This is the Working Group **Recirculation** ballot draft, D2.0, of IEEE P802.3aa Maintenance Revision #5 (100BASE-T.) This document has been revised since D1.1 to reflect the resolution of comments received during the Working Group ballot which closed July 3, 1997.

IEEE802.3 WG Ballot 1st WG Recirculation Ballot, 10/28/97 Subject: P802.3aa Maintenance #5 (100BASE-T) (Revision to CSMA/CD, 100 Mb/s Operation)

1 P802.3aa, 802.3 MAINTENANCE BALLOT #5 (100BASE-T) 2 CHANGE 1: Changes to Partition State Diagram for Port X (Figure 27-8) 3 Clause 27: Repeater for 100Mb/s baseband networks 4 **Proposed by: Lloyd Oliver** 5 Approved for ballot 11/12/96 6 7 **PROPOSED CHANGES** 8 9 In Figure 27-8 Repeater Partition State Diagram for Port X: 10 1) Change transition: ¹¹ COLLISION COUNT IDLE to WATCH FOR COLLISION 12 Update to read: 13 14 (scarrier present(x) = true) + (command(x) \neq quiet) ¹⁵ This ensures that the COLLISION COUNT IDLE state is exited for both receive activity 16 (scarrier present(x) = true) and transmit activity (command(x) \neq quiet). The term (com-17 $\frac{1}{18}$ mand(x) \neq quiet) has to be ORed in to ensure transmits also cause an exit from the COLLI-19 SION COUNT ID

2 3 27.7.4.8 Partition function

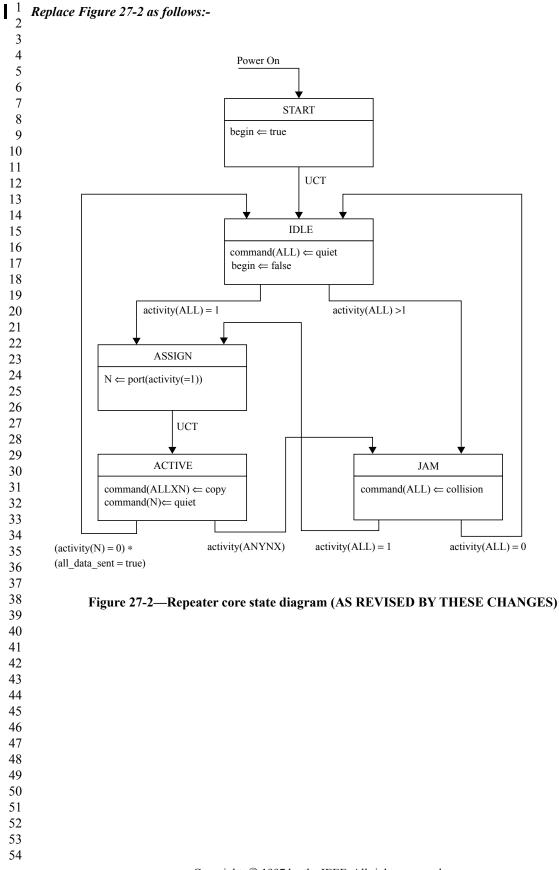
Change 27.7.4.8 as follows (change bars, underline and strikethrough are against base document):-

Item	Feature	Subclause	Status	Support	Value/Comment
PA1	Partition function implementa- tion	27.3.1.6	М		Self-interrupt of data reception
PA2	Consecutive Collision count for entry into partition state	27.3.1.6	М		Consecutive-Collision count greater than or equal to in- excess of CCLimit
PA3	Consecutive Collision counter incrementing	27.3.1.6	М		Count incremented <u>on a colli-</u> sion on each transmission that suffers a collision.
PA4	Consecutive-Collision counter reset	27.3.1.6	M		Count reset on successful coll sion.
<u>PA4</u>			M		<u>Count reset on receive activ-</u> <u>ity in excess of</u> <u>no collision timer without</u> <u>collision</u>
<u>PA5</u>			<u>OPF:M</u>		<u>Count reset on transmission in excess of no_collision_timer</u> without collision
PA 5 6	Messages sent to repeater unit in Partition state	27.3.1.6	М		Inhibited sending messages to repeater unit
PA <u>67</u>	Messages sent from repeater unit in Partition state	27.3.1.6	М		Continue sending output mes- sages

PA7 <u>8</u>	Monitoring activity on PMA interface in Partition state	27.3.1.6	М		Continue monitoring activity a PMA interface
PA8	Reset of Partition state	27.3.1.6	M		Power-up reset or Detecting- activity for greater than dura- tion no_collision_timer with- out a collision
<u>PA9</u>			M		Power-up reset or transmis- sion in excess of no_collision_timer without collision
<u>PA10</u>			<u>OPF:M</u>		Receive activity in excess of no collision timer without collision
<u>PA11</u>	Excessive carrier entry into Partition state	27.3.1.6	<u>OPF:M</u>		Carrier duration in excess of jabber timer in which a collision occurs

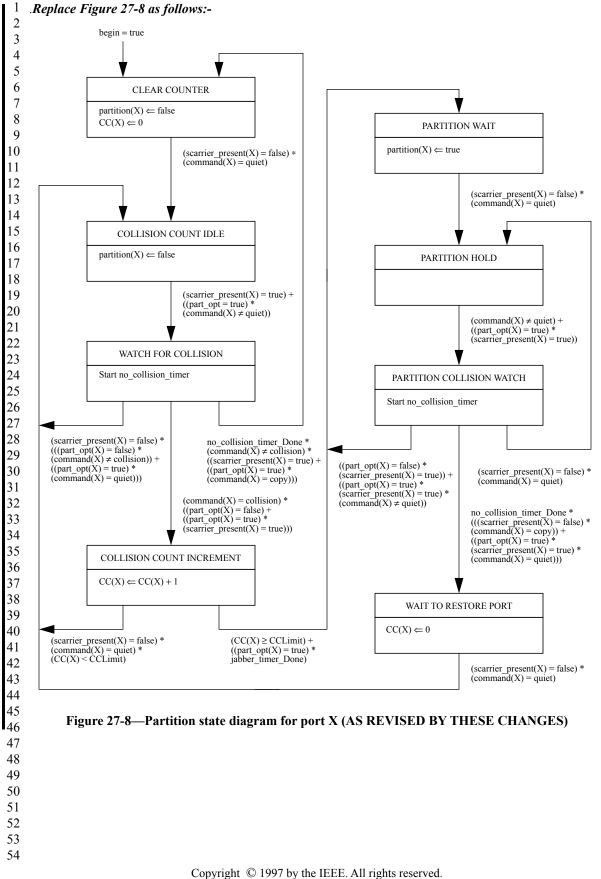
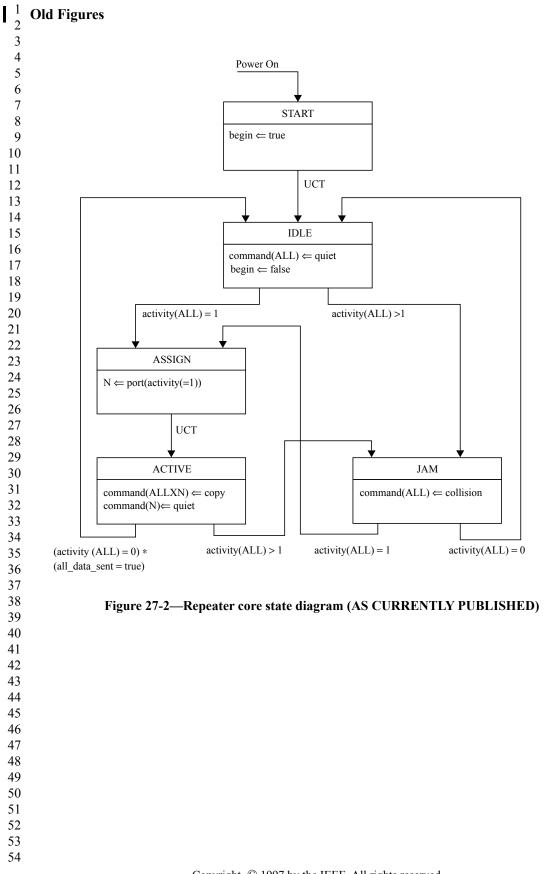
- 47 This change ensures that either a transmit or a receive for duration greater than
- ⁴⁸ no collision timer will reset the collision counter.
- $\frac{49}{50}$ 5) Change transition:
- 51 PARTITION HOLD to PARTITION COLLISION WATCH
- 52 Update to read:
- $\begin{array}{l} 53\\54 \end{array} (command(x) \neq quiet) + (scarrier_present(x) = true) \end{array}$

- 4 6) Change transition:
- ⁵ PARTITION COLLISION WATCH to PARTITION WAIT
- $^{6}_{7}$ Update to read:
- $\frac{1}{8}$ (command(x) \neq quiet) * (scarrier_present(x) true)

- 9 This change ensures that if a receive is occurring while the port is transmitting (Com-
- $10 \mod(x) = \text{copy or collision}$ the port remains partitioned.

- $\frac{11}{12}$ 7) Change transition:
- 13 PARTITION COLLISION WATCH to WAIT TO RESTORE PORT
- ¹⁴ Update to read:
- $\frac{15}{16} \text{ no_collison_timer_Done * (((scarrier_present(x) = false) * (command(x) = copy)) + }$

- $\frac{16}{17} \text{ ((scarrier_present(x) = true) * (command(x) = quiet)))}$
- 18 This change ensures that a receive receipt of a good packet as well transmitting as trans-
